Document Type	DCC Number	February 14, 2008
	T080034-01-C	
UK Top Driver Pre-Production Prototype Bench Test and Evaluation		
J. Heefner, T. Etzel

This test report documents the bench test results and evaluation of the AdL Suspension Top Driver chassis supplied as a pre-production prototype by the University of Birmingham. Bench tests were conducted in accordance with LIGO document number T080014-00-C, “AdL UK Top Coil Driver Pre-Production Test Plan”. A link to the completed test plan with results is included in Appendix A of this document. The design requirements for the Top Driver can be found in LIGO document number T060067-00-C, “AdL Quad Suspension UK Coil Driver Design Requirements”.

Figure 1: Top Driver Chassis Front View

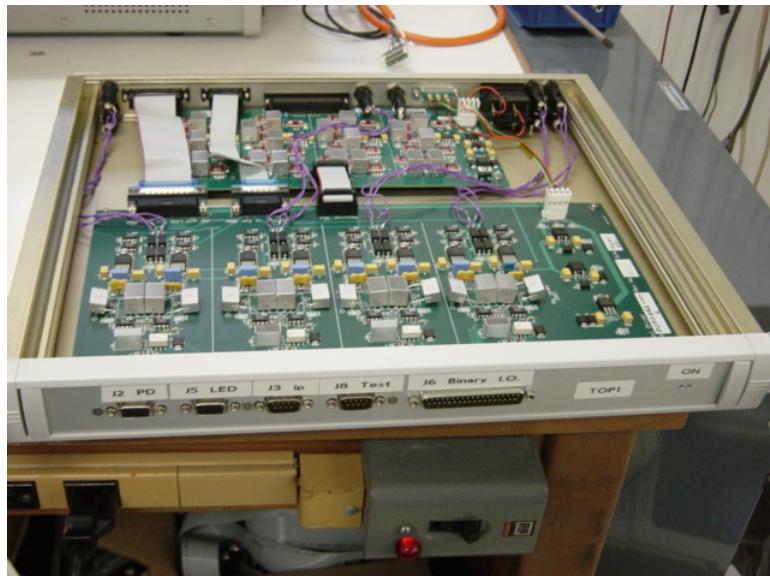
As can be seen from the photos, front and rear panel labels have been made using a label maker. In the full production units these labels should be implemented in a more permanent manner such as engraving or permanent stenciling. The drawing number associated with the chassis assembly drawing should also be added to front or rear panel labels.

Power indicators are included on the front panel, but the power indicators for the monitor board are inside the chassis and there are no indicators on the rear panel. It would be advantageous if there were some indication of power status on the rear of the chassis near the power switch.

Figure 3: Top Driver Circuit Board

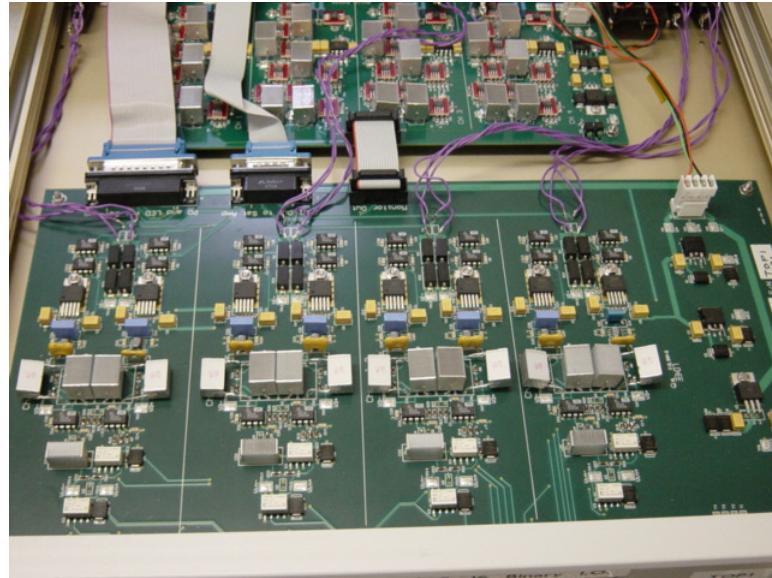
The photo below is a closer view of the Top Driver board. As can be seen from the picture, the circuit board is multi-layer, professionally manufactured circuit board. The larger silver objects running down the middle of the board are capacitors. Several of these capacitors are installed laying down because the footprint on the board was not correct for the component. This is expected in a pre-production prototype, but the footprints should be corrected prior to production. Additionally, the purple wiring leading from the driver board to the fuseholders mounted on the rear of the chassis is soldered directly into the board and the wires routed directly over and sometimes are in contact with the low noise circuitry of the rear mounted monitor board (see Monitor Board picture below). Prior to production wire attachment and routing and fuseholder placement should be rethought and if possible, the wires eliminated by using some type of board mounted fuseholder that protrudes from either the front or rear panel of the chassis. This could require a significant amount of board layout and chassis redesign. The board label on the silkscreen for the board also needs to be corrected. It incorrectly identifies the board as the UIM Coil Driver.

The Top Driver Board is capable of producing currents in excess of 200 mA per channel. The trace widths for these high currents paths appear to be 10-12 mils. Although this may be adequate, it is recommended that these widths be increased to a minimum of 25mils (0.635 mm).

Figure 4: Top Driver Monitor Board

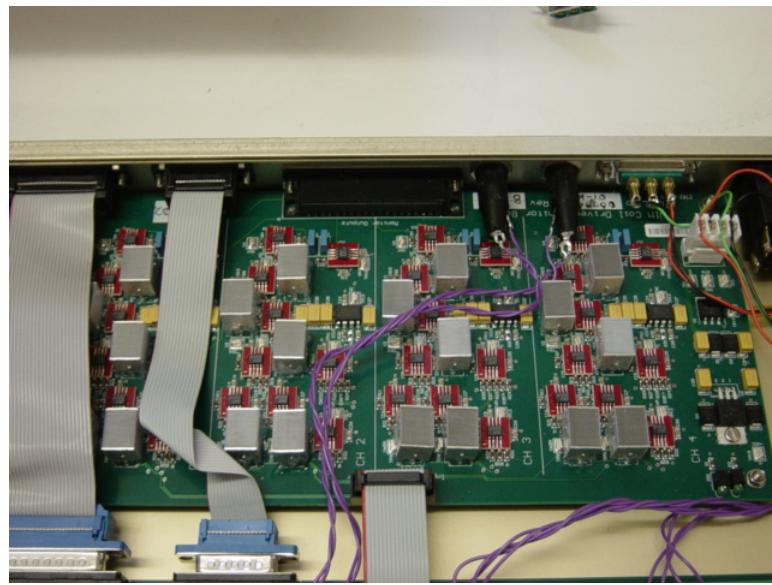
The Monitor board was manufactured in a similar fashion and the only circuit board issue observed was that the mounting hole size for the 37 pin sub D connector were not correct. This should be corrected prior to production. Both boards (driver and monitor) are identified in the space provided with the drawing number, revision number and serial number for the board. The circuit board (pcb artwork) revision number is included on the silkscreen for each board.

Figure 5: Close up of Top Driver Chassis Power Connections

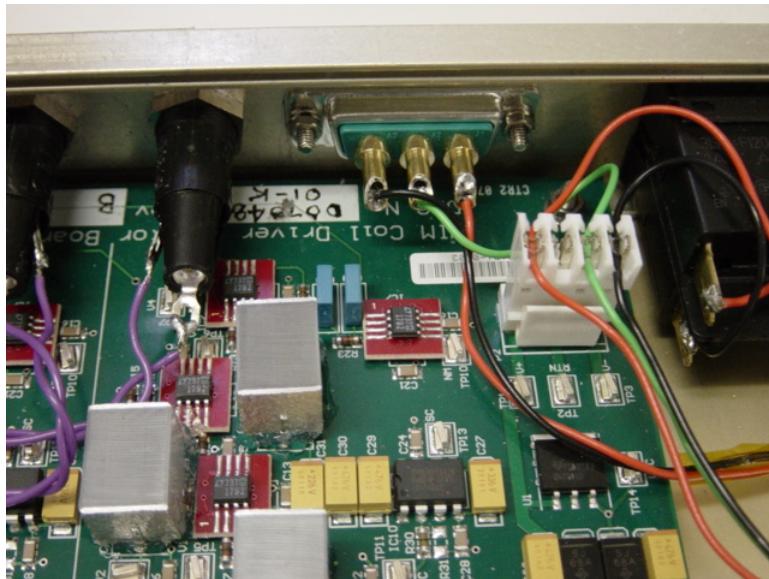
The photo below is a closer view of the input power connections and chassis power wiring. As can be seen from the picture, the solder connections to the rear mounted power connectors are not adequate and wire colors used do not follow the LIGO power wiring color code. In this case, the positive voltage, return and negative voltage wire colors should be white, black and green, respectively. Heat shrink should be included over the power connector pins to prevent inadvertent shorting of the pins. Additionally, the Molex connectors used for connection to the header are the IDC style without the retaining clip installed. It is strongly recommended that these connectors be replaced with the crimp pin version.

Figure 6: Measured and Simulated Top Driver Output Noise

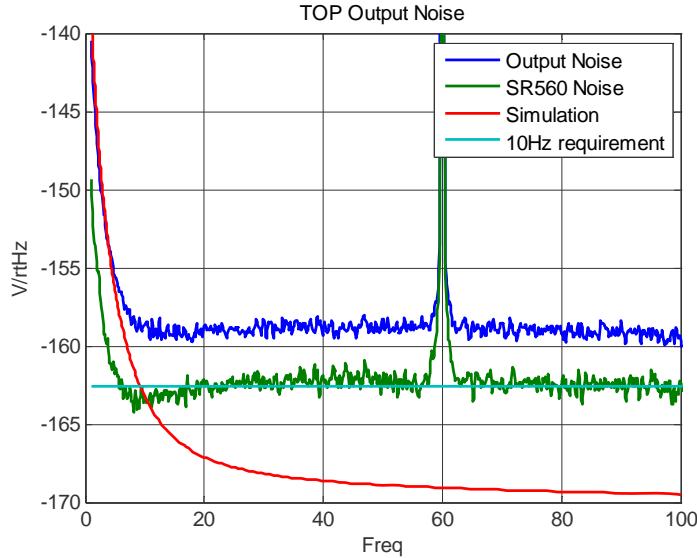
Note that the simulation predicts that the design submitted by the University of Birmingham should meet the requirements. The measured noise (blue) is approximately 3 dB higher than the requirement, but the noise floor of the SR560 amplifier used during the test falls right on the 10Hz requirement line. Assuming that noise of the SR560 and the Top Driver are not correlated and add in quadrature, this would imply that the Top Driver noise is equal to the SR560 noise and therefore meets the 10Hz requirement. The driver noise is below the requirements at the other frequencies.

During testing it was noticed that installing link W1 and W2 seemed to relieve an oscillation seen before capacitors C100 and C101 were installed. It is recommended that this oscillation be investigated to determine if it has been eliminated completely and is not causing additional noise when large voltages are present. This can be checked by applying a large, low noise DC voltage to the driver inputs and repeating the output noise measurements in section 3.2 of the test plan.

Figure 7: Noise Monitor Noise Referred to Driver Output

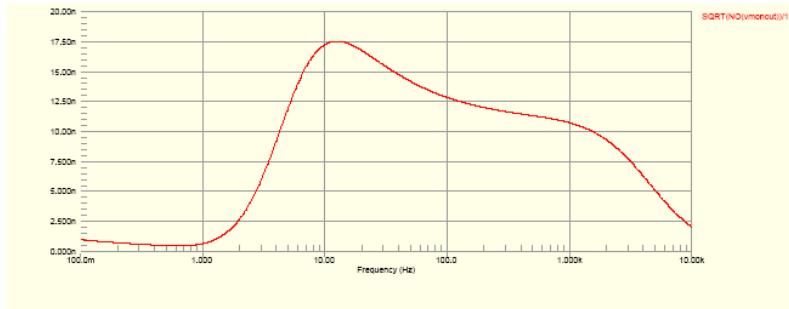
The tests results in section 3.5.2 of the test plan appear to confirm the simulation. If the simulation is correct and the requirement is a “firm” requirement, then the noise monitor circuit will need to be redesigned such that the input-referred noise of the noise monitor circuit is below $8\text{nV}/\sqrt{\text{Hz}}$. Note that the input of the noise monitor is defined as the point that ties to the output legs of the driver circuit.

Figure 8: Simulated and Actual Transfer Function

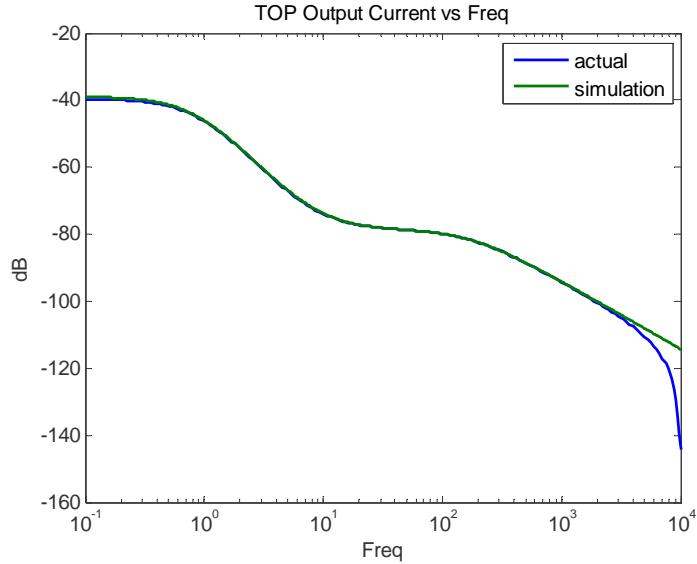
Note that the traces agree very well. The deviation at high frequencies is due to the roll off of the AA filter used as a differential driver for the chassis. Close examination of the data taken and recorded in the test plan shows that the actual measurements are consistently 0.7dB lower than predicted for low frequencies. This is similar to the 10% deviation seen in the dynamic range tests.

Figure 10: Typical Cross Coupling Measurement Results

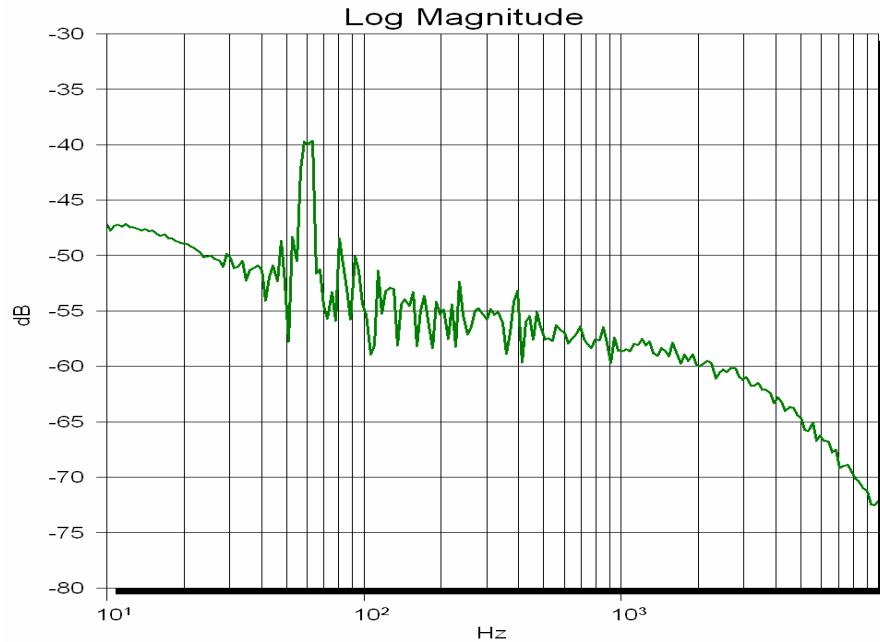
As can be seen from the plot, the highest coupling measured was approximately -47dB at 10Hz. The gain of the noise monitor at 10Hz is 42dB. This leads to an isolation of approximately 89dB from the input of one channel to the output voltage of another channel on the board. This should be acceptable for AdL. Note that the peak seen at 60Hz is most likely a line harmonic, not cross-coupling and was therefore ignored.
